# UNITED STATES PATENT AND TRADEMARK OFFICE

APPLICATION NO.	FILING DATE	FIRST NAMED INVENTOR	ATTORNEY DOCKET NO.	CONFIRMATION NO.
10/621,194	07/15/2003	Ford B. Grigg	108298637US1	2349
25096	7590	06/03/2005	EXAMINER	
PERKINS COIE LLP			ANDUJAR, LEONARDO	
PATENT-SEA			ART UNIT	
P.O. BOX 1247			2826	
SEATTLE, WA 98111-1247			PAPER NUMBER

<b>Office Action Summary</b>	<b>Application No.</b>		<b>Applicant(s)</b>	
	10/621,194		GRIGG, FORD B.	
	<b>Examiner</b>		<b>Art Unit</b>	
	Leonardo Andújar		2826

## **DETAILED ACTION**

Fig. 13

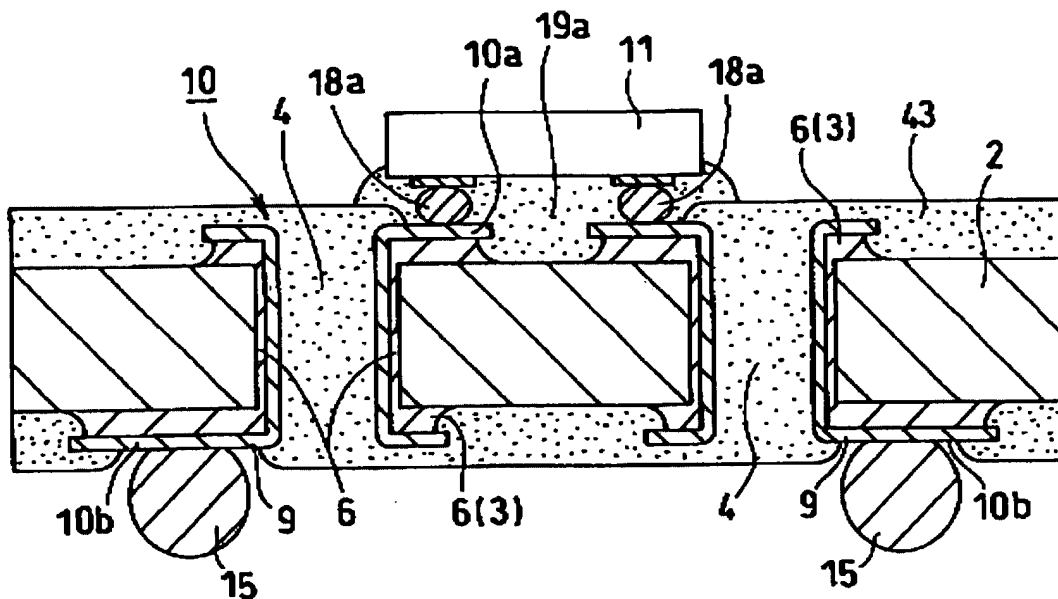
4. Regarding claim 38, Nakata (e.g. fig. 13) shows a microelectronic die having an integrated circuit 11 and a plurality of bond-pads (the die region contacting the bumps 18a) coupled to the integrated circuit; an interposer substrate 2 having a first side coupled to the die, a second side opposite the first side, a plurality of ball-pads 10b arranged on the second side to be coupled to a printed circuit board (col. 9/lis. 52-53), interconnects 18a electrically coupled to the bond-pads on the die and the ball pads; and a solder-mask 43 having openings over the ball-pads; a plurality of solder-balls 15 arranged so that each solder-ball is in an opening in the solder-mask and contacting a

corresponding ball-pad. Nakata does not show a dielectric compound surrounding a portion of the perimeter of each of the ball-pads and the solder-balls.

6. Regarding claims 40 and 45, Nakata (e.g. fig. 13) shows a microelectronic die having an integrated circuit 11 and a plurality of bond-pads (the die region contacting the bumps 18a) coupled to the integrated circuit; an interposer substrate 2 having a first side coupled to the die, a second side opposite the first side, a ball-pad 10b arranged on the second side, an interconnect 18a electrically coupled to the bond-pad on the die and the ball pad, a trace line 9/3 adjacent to the ball pad, and a solder-mask 43 having an opening over the ball-pad; a solder-ball 15 on the ball pad. Although Nakata shows

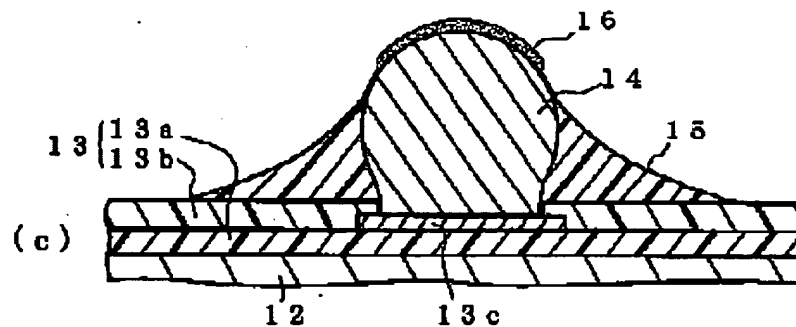
Nevertheless, Shoji (e.g. fig. 3c) shows a dielectric compound 15 (e.g. polyimide; see attached translation pp 0028) surrounding a portion of the perimeter of the ball-pads 13 and the solder-balls 14. Because the base of a solder ball/projection electrode 14 can be reinforced by the film/dielectric compound 15, even when the coefficient of thermal expansion of two members which connect through this projection electrode differs greatly, a crack etc. does not arise with thermal stress in a projection electrode. And since reinforcement can be carried out only to the base of a projection electrode, it is not necessary to make the member for reinforcement intervene between two members which connect mutually through this projection electrode. For this reason, since said two members can be made to separate after mounting so that a projection

electrode may become on a boundary, this is easily exchangeable even if one side of these two members is a defective (i.e. easy reworkability, see 0051)

It would have been obvious to one of ordinary skill in the art at the time the invention was made to form a dielectric compound surrounding a portion of the perimeter of each of the ball-pads and the solder-balls disclosed by Nakata including a portion of the perimeter of each of the ball-pads and the solder-balls as suggested by Shoji to prevent cracks due to difference in thermal expansion coefficient while providing easy reworkability.
